FOUNDATION INVESTIGATION  
PROPOSED BRIDGE REPLACEMENT  
CROSSING AT THE NORTH CHANNEL  
WEST ARM OF LAKE NIPISSING  
TOWNSHIP OF HADDON  
DISTRICT OF SUDBURY, ONTARIO  
YOUR REF. W.P. 73-73-04  
*COPY 75-95*

RE: Foundation Investigation  
Proposed Bridge Replacement  
Crossing at the North Channel  
West Arm of Lake Nipissing  
Township of Haddo  
District of Sudbury, Ontario  
Your Ref. W.P. 73-73-04

Re : Preliminary Plan  
West Area Lake Nipissing Bridge  
North Branch  
W.P. 73-73-04 : Site # 43-123  
District # 13, (North Bay)

BORE HOLE LOCATIONS & SOIL STRATA

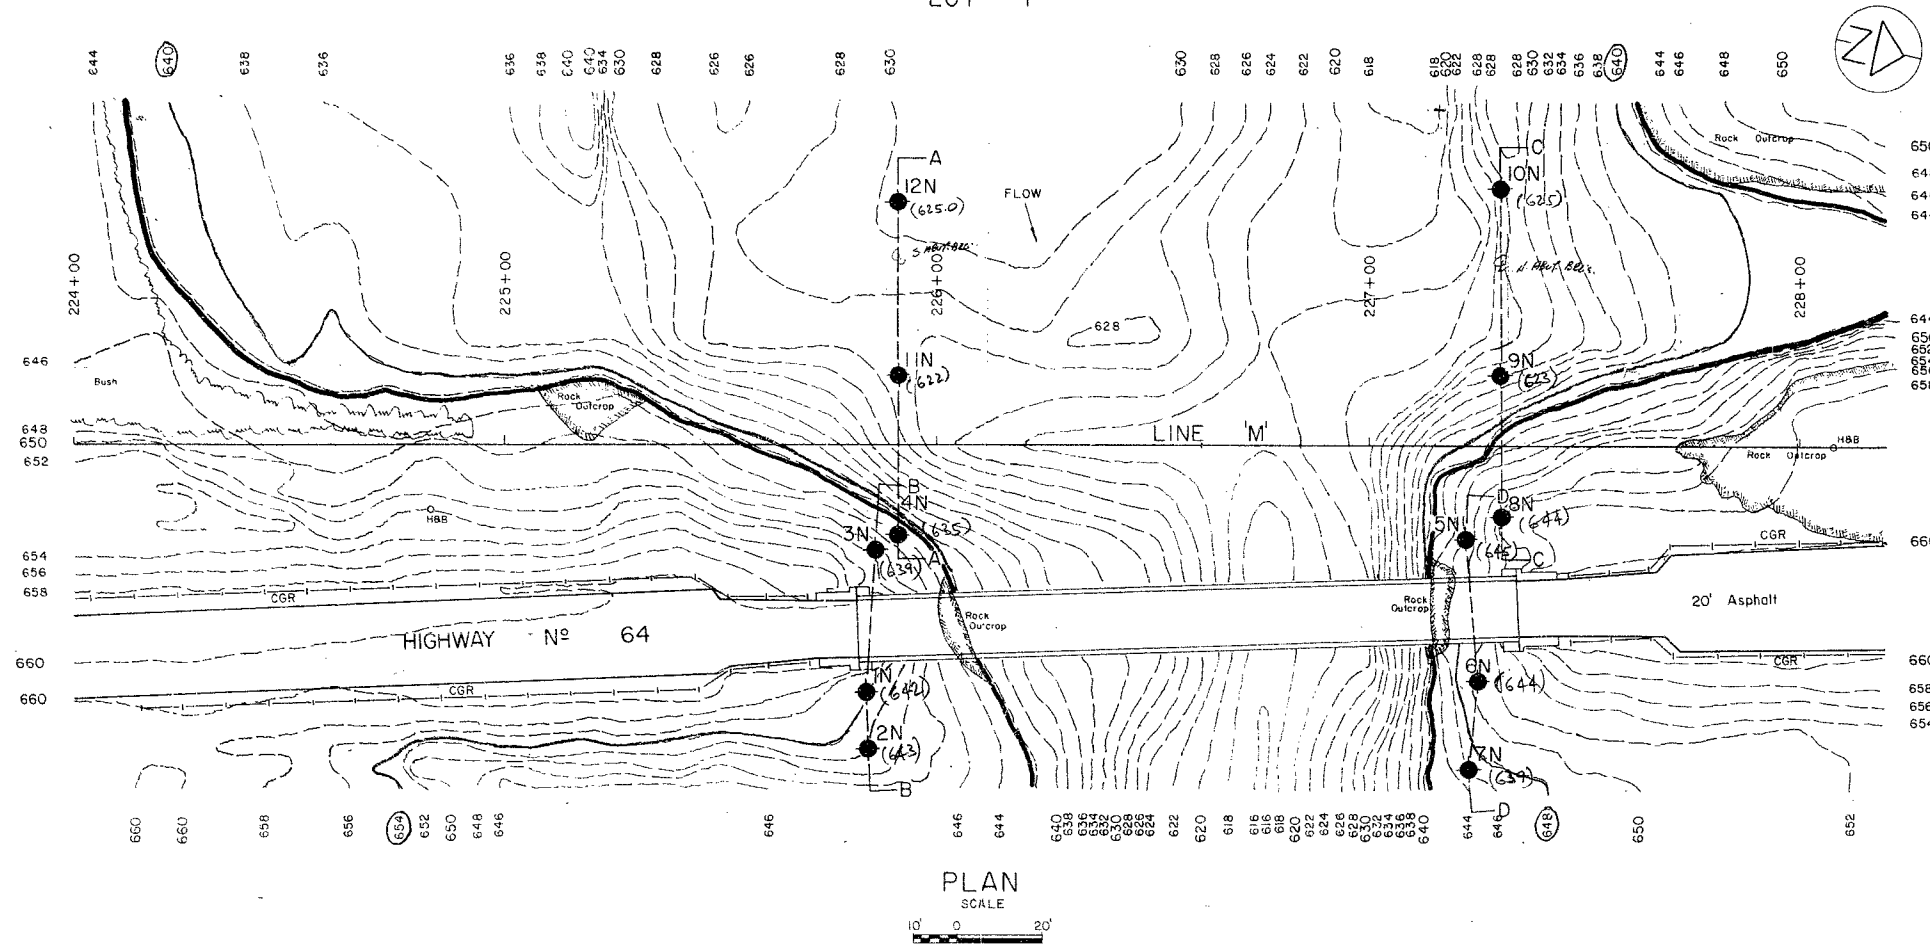
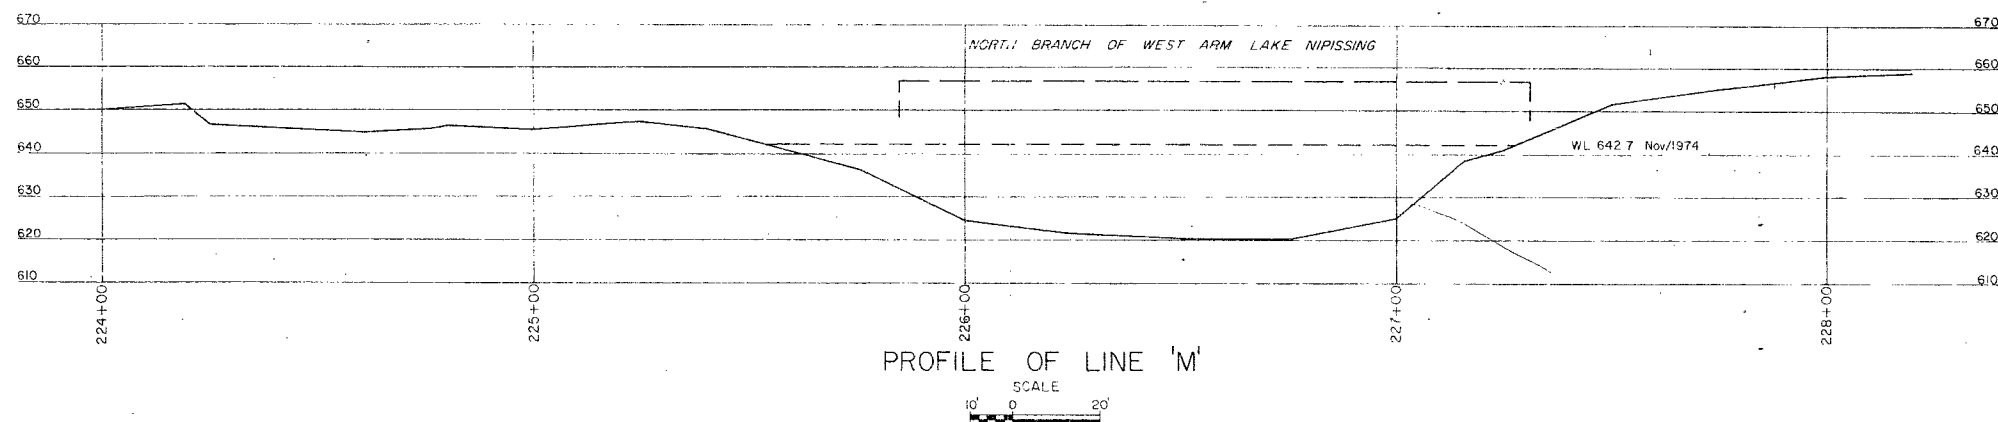
The bedrock should be shown at borehole locations only, and should not be connected by means of a straight line between the boreholes. A similar correction is being made on the foundation drawing.

As discussed with Messrs. M. Devata and A. Prakash, I enclose our revised drawing showing the interpreted soil strata for the above noted project.

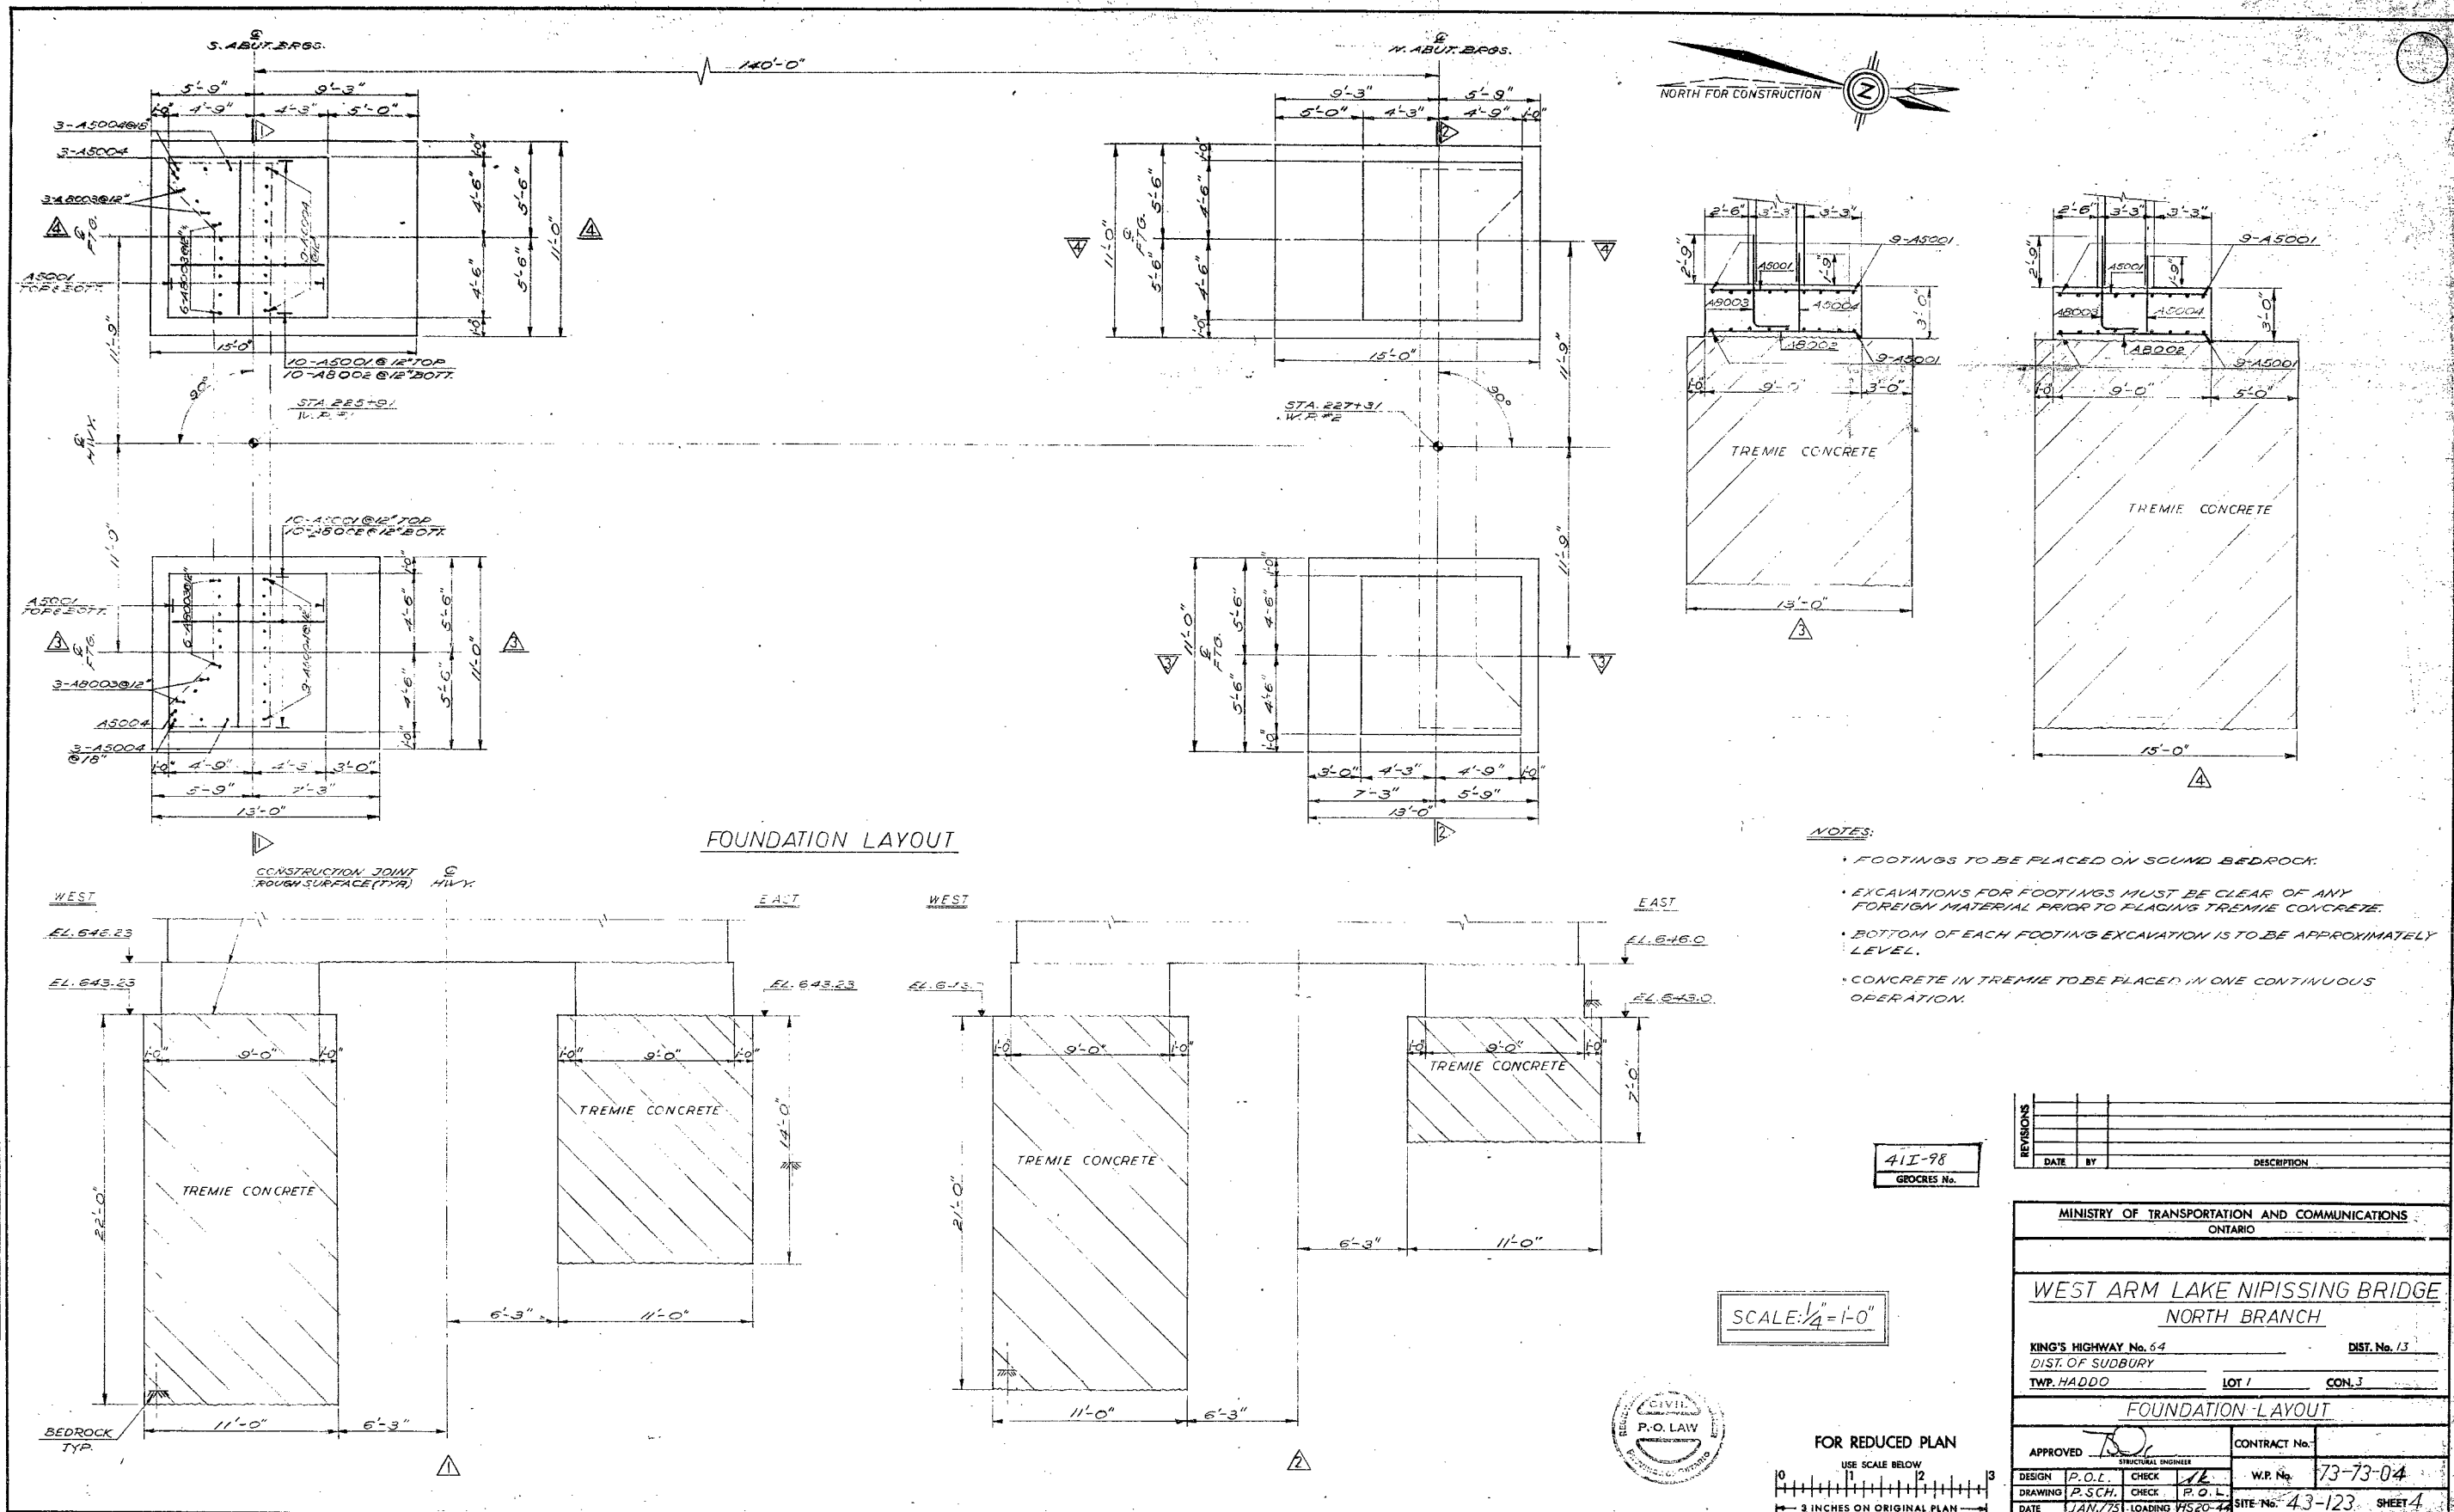
Bedrock elevations shown on Sheet 3 do not agree with the elevations shown on the foundation drawing prepared by William Trow Associates Ltd. Elevations of bedrock surface in various boreholes, according to Trow Associates are as follows:
